EASTERLY ALTERNATION INFRASTRUCTURE PROJECT

Environmental Impact Assessment Environmental Statement, Volume III Appendix 1.6 Scoping Opinion

Document Reference: 19309-XX-EC-XXX-000025

EASTERLY ALTERNATION INFRASTRUCTURE PROJECT ENABLING WORKS TO FACILITATE THE ENDING OF THE CRANFORD AGREEMENT HEATHROW AIRPORT

Graphic 2.5 Direction of arrivals and departures on 09R and 09L during easterly operations (proposed)

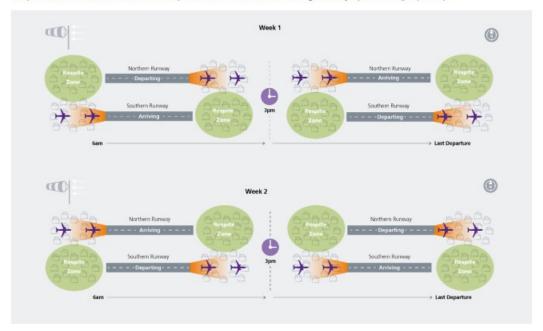
The main effect in air quality terms would be the increase in the number of aircraft departing on the northern runway (09L) and arriving on the southern runway (09R) during easterly operations and the decrease in the number of aircraft departing on the southern runway (09R) and landing on the northern runway (09L) during the same mode of operations.
